NUMBER: 18-101-22

This bulletin supersedes Technical Service Bulletin (TSB) 18-010-21 REV. B, date of issue June 25, 2021, which should be removed from your files. All revisions are highlighted with **asterisks**** and includes updated notes and inspection section.**

Flash: Powertrain Control Module (PCM) Updates

2019	(DJ)	RAM 2500 Pickup
2019	(D2)	RAM 3500 Pickup

Fig. 1
CP3.3 Design Pump

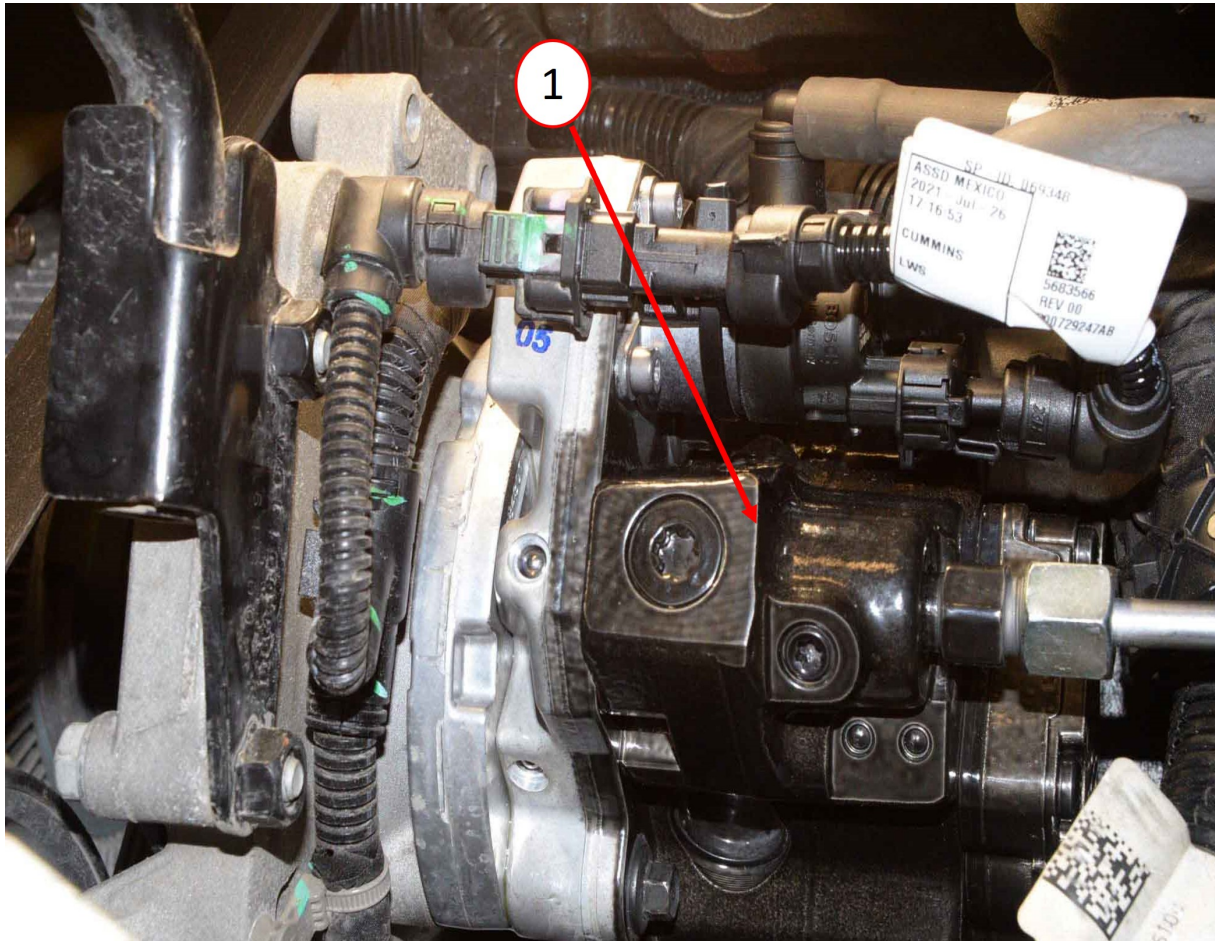
NOTE: **The only calibration available will be for the updated CP3.3 design High-Pressure Fuel Injection Pump (Fig. 1) . Please ensure that recall Y78 has been completed first before proceeding with this update.

1. Inspect the High-Pressure Fuel Injection Pump to see which pump is currently installed on the vehicle (Fig. 1) . Also review the vehicle VIP report to see if campaign Y78 has been performed.

2. Does the VIP report indicate that Y78 has been performed, and is the vehicle equipped with the new design fuel injection pump released under the campaign?
 - YES>>> Proceed to [Step 1](#).
 - NO>>> Perform the Y78 campaign first. Once the campaign is performed, new pump installed and PCM updated, the PCM will have all of the updates listed in this document. This Bulletin does not apply.**
